RESPONSE LETTER

Manuscript Number: egusphere-2026-1378

Title: Managed Aquifer Recharge in Confined Multi-Layer Aquifers: A Scalable Framework for Drought Resilience in Central Europe

Response to the Reviewer #1:

Table S2. Lag-correlation analysis for SPEI-1, SPEI-3, SPEI-6, and SPEI-12 vs SGI

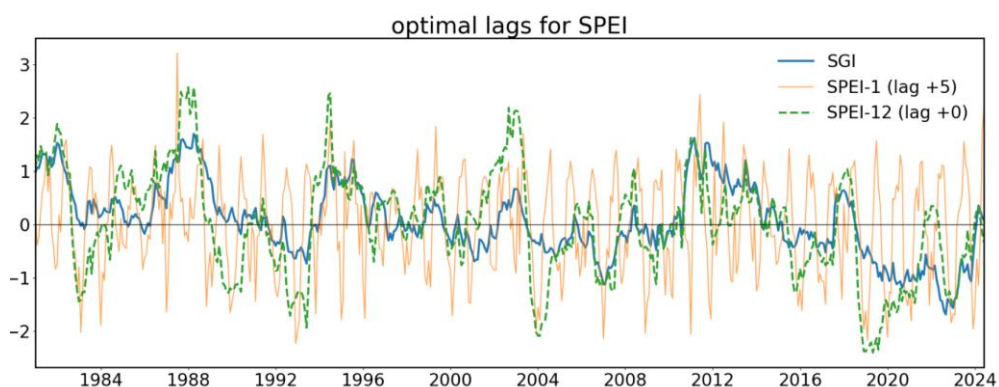
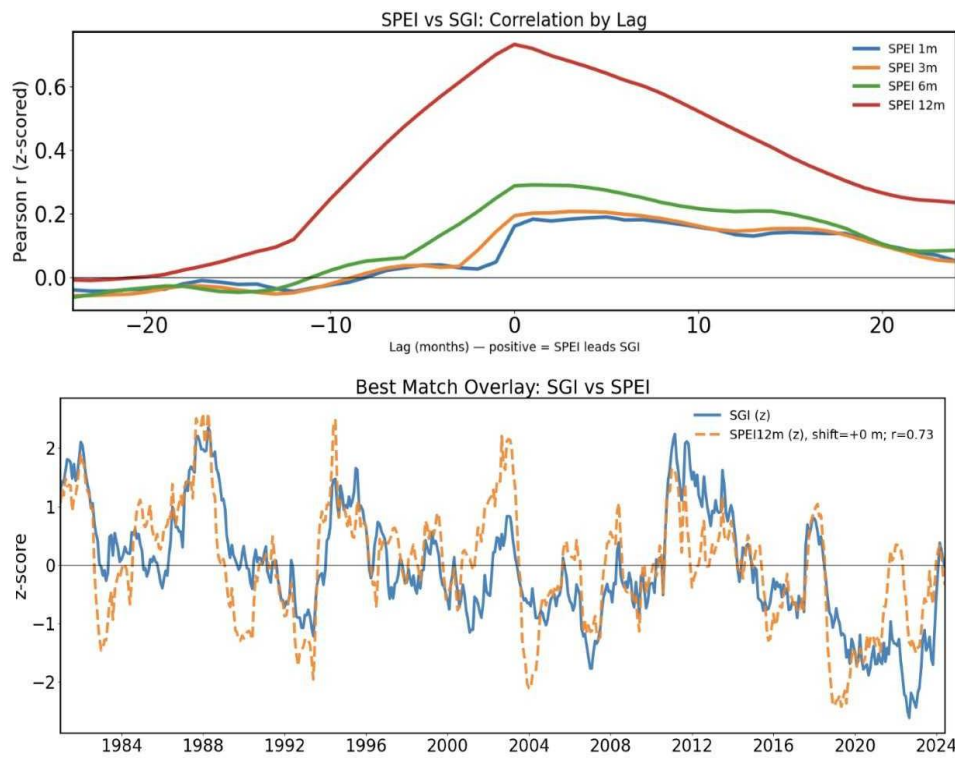
1) The authors report a high pearson correlation between SPEI-12 and SGI with "no lag". This is an interesting finding for a confined multi-layer aquifer system, where pressure propagation rather than direct recharge drives head changes. The manuscript does not sufficiently explain the hydrogeological mechanism behind this near-instantaneous coupling. In confined systems, piezometric responses can be rapid, but this is a different mechanism than moisture storage response observed in unconfined systems. This distinction must be clearly discussed and reconciled with the literature.

It would be more correct, rather to state that the absence of lag between SPEI 12 and SGI "indicates that groundwater levels in this confined aquifer respond almost immediately to climatic anomalies" (Discussion section, lines 487-488) to state that the time scale of the response process of groundwater levels to climatic anomalies is not detectable by the aggregated annual scale of SPEI 12 compared with SGI.

Due to the importance of this statement in discussion and conclusion section, to avoid misinterpreting of results and findings, a montly based analisys using SPEI 1 would be recommended to eventually detect and quantify lags or strongly confirm the "immediate response of GW to climate variability" statements of the whole manuscript.

We thank the reviewer for this important and constructive comment. We agree that the previous wording could be misinterpreted. We have changed the wording to avoid misinterpretation, clarifying that the absence of a detectable lag at the SPEI-12 scale does not demonstrate an immediate physical recharge response. Rather, it indicates that the response time of groundwater levels to climatic anomalies is not resolved by the 12-month accumulated SPEI timescale. Because SPEI-12 already integrates the climatic water balance over the preceding year, a zero-lag correlation means that SGI co-varies with annual-scale climatic anomalies, not that groundwater storage responds instantaneously.

Following the reviewer's suggestion, we performed a monthly lag-correlation analysis using SPEI-1, SPEI-3, SPEI-6, and SPEI-12 against SGI for lags of 0–24 months. The SPEI-1 analysis showed only weak correlations with SGI ($r = 0.108$ at 3-month lag), whereas correlations increased for longer accumulation periods and were strongest for SPEI-12 at zero lag ($r = 0.632$, $r^2 = 0.40$). This supports the interpretation that the groundwater system primarily reflects accumulated climatic anomalies over multi-month to annual timescales rather than individual monthly anomalies (please see new Table S2 in Supplementary Materials).

Index	Best lag	Pearson r	r ²	n	Interpretation
SPEI-1 vs SGI	5 months	0.191	0.036	533	Very weak
SPEI-3 vs SGI	3 months	0.208	0.043	531	Very weak
SPEI-6 vs SGI	1 month	0.291	0.085	528	Weak
SPEI-12 vs SGI	0 month	0.734	0.539	522	Strongest

Figure 4. Methodological flowchart illustrating the sequential structure of the integrated ASTR feasibility assessment framework, from data processing and analytical components to final suitability and economic outputs.

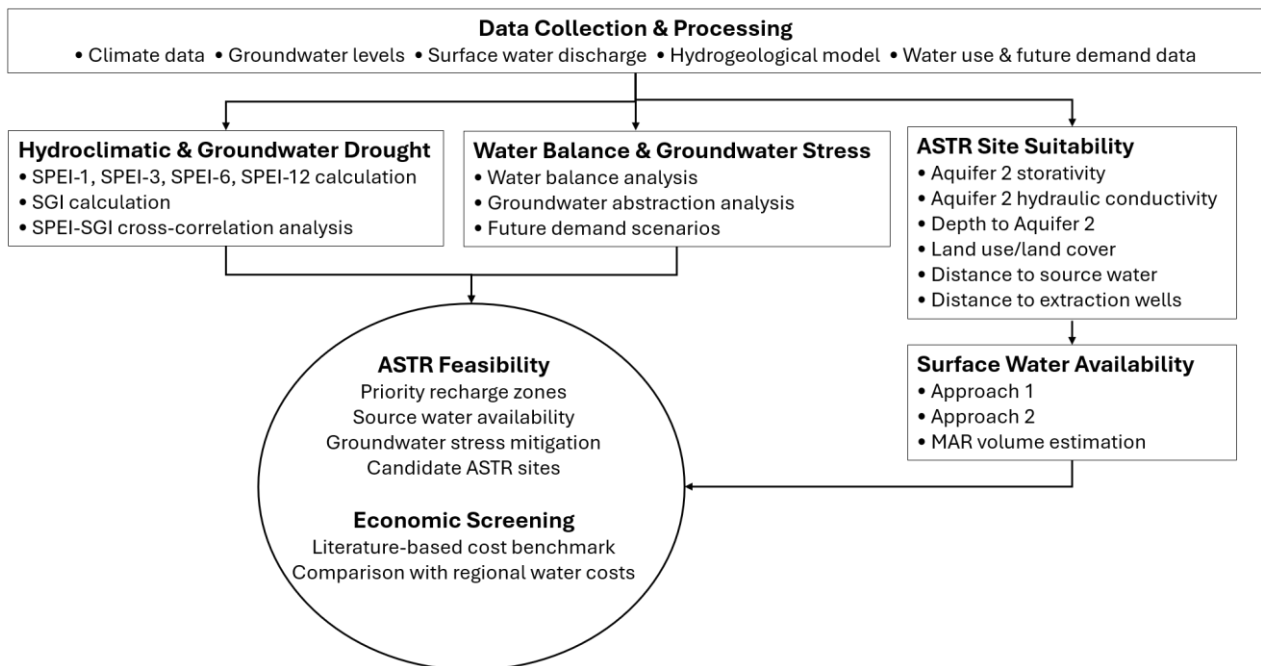
3) Globally, a flowchart image of the methodology would enrich methodological section.

We thank the reviewer for this valuable suggestion. We agree that a flowchart significantly improves the clarity of our complex methodology. We have added a comprehensive methodological flowchart (Fig. 4) that illustrates the sequential structure of our framework, starting from data processing, through the four main analytical components (drought assessment, water balance, GIS-MCDA, and flow-threshold analysis), culminating in the final ASTR suitability and economic outputs. A reference to this figure has been added to Section 3.

The overall structure and sequential progression of the methodological framework are illustrated in the flowchart (Fig. 4), which integrates hydroclimatic drought assessment, GIS-MCDA site suitability, surface water availability, and economic screening.

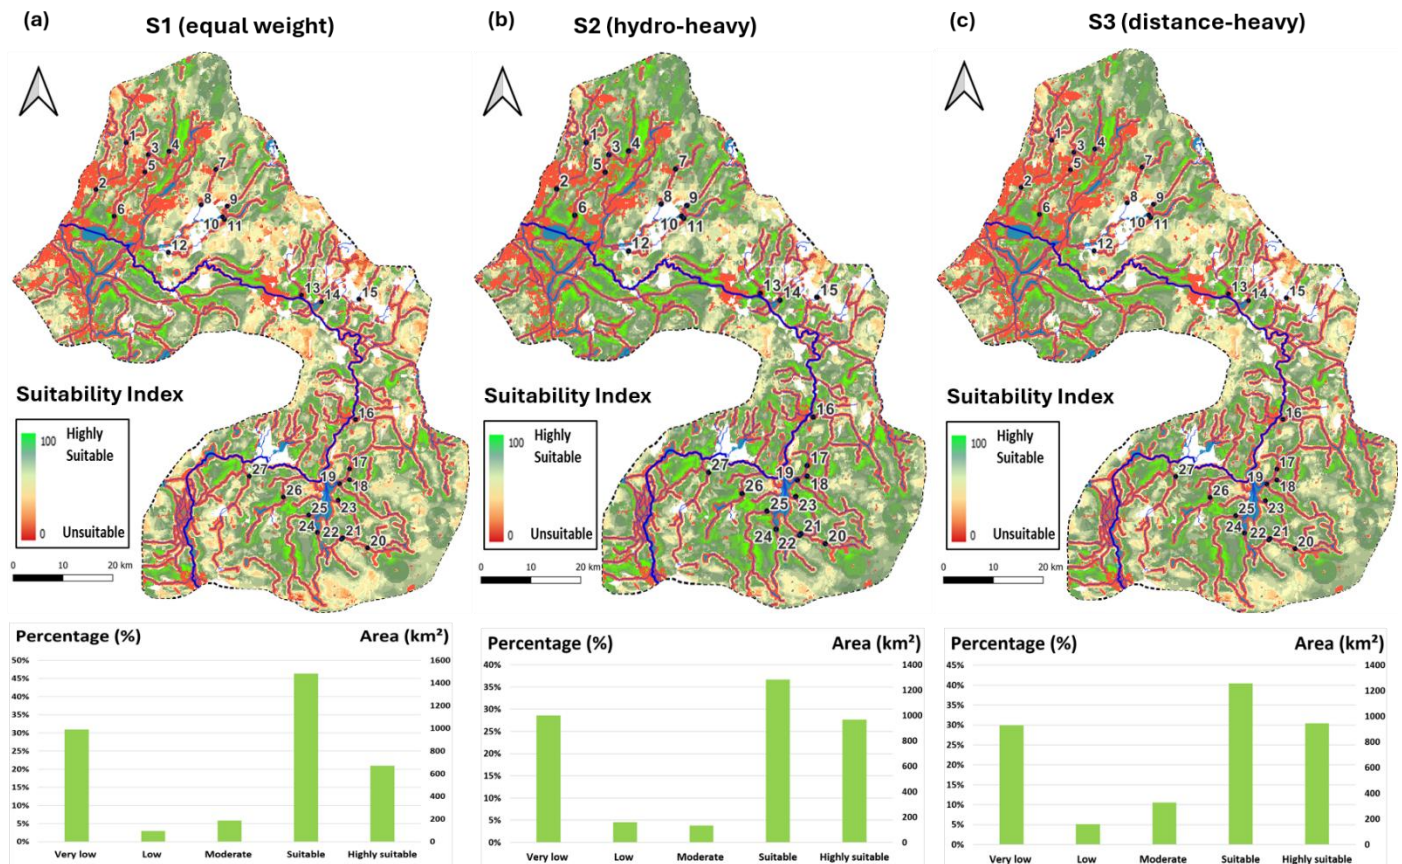
4) In section 3.4, regarding the MCDA procedure for selecting site suitabilities for ASTR and MAR, you selected six site-selection criteria and classify their suitability scores. MCDA applications in groundwater related Issues, such as groundwater potential recharge evaluation and mapping, are very common in scientific literature of recent Years; often exploring and selecting different ranges of criteria due to case specific needs or constrains. In your case, criteria selection seems to be arbitrary or author-knowledge based, as well as the attributed scores in table 1 and their range values, which can be acceptable only if properly justified for the characteristics of your case study and strongly linked to scientific literature and to the purpose of your study. In any case, your choices have to be properly framed in the context of contemporary scientific literature on the topic. From both aspects, this methodological section of the manuscript is weak and needs improvements.

5) Moreover, regarding MCDA procedure, you apply equal weighting to all six MCDA criteria. It is well-known that weighting choices strongly influence MCDA outcomes in MAR suitability studies. The manuscript acknowledges this only in passing ("based on literature and expert judgment"). A sensitivity analysis testing alternative weighting schemes is strongly recommended.

To address concerns about arbitrary weighting, we performed a sensitivity analysis using three distinct weighting scenarios (equal weight, hydro-heavy, and distance-heavy). Results demonstrate high robustness: the "Very Low" suitability class remained stable at ~29% across all scenarios (variation <0.3%), and high-suitability zones stayed in the same geographic locations. This confirms that identified priority zones are controlled by actual physical constraints rather than subjective weight assignments (Hani et al., 2023; Vandala and Mahed, 2025). We have updated Sections 3.4 and 4.3, added Tables 2–3, and revised Figure 6 to present these findings.

Sensitivity Analysis Results: We tested three weighting scenarios (Table 2). Results demonstrate high robustness (Fig. 6; Table 3). The "Very Low" suitability class remained stable at ~29% across all scenarios (variation <0.3%), indicating physical constraints consistently define unsuitable areas. The "Suitable" class showed moderate variation (36.7-43.3%; $\Delta = 6.6\%$), while "Highly Suitable" areas varied between 17.2% (S3) and 27.7% (S2) ($\Delta = 10.5\%$).

Despite percentage variations, the spatial distribution of high-suitability zones remained geographically consistent across all scenarios (Fig. 6a-c), confirming that site suitability is primarily controlled by underlying physical characteristics rather than subjective weight assignment (Hani et al., 2023; Vandala and Mahed, 2025).

schemes: (S1) equal weighting, (S2) hydro-heavy weighting (prioritizing storativity and hydraulic conductivity), and (S3) distance-heavy weighting (prioritizing proximity to source water and wells). The results (new Figure 6, Tables 2–3) confirm that while class proportions shift slightly, the spatial location of high-suitability zones remains consistent across all scenarios. This demonstrates the robustness of our findings and confirms that identified priority zones are controlled by actual physical constraints rather than subjective weight assignments. This sensitivity analysis has been explicitly added to Section 4.3.
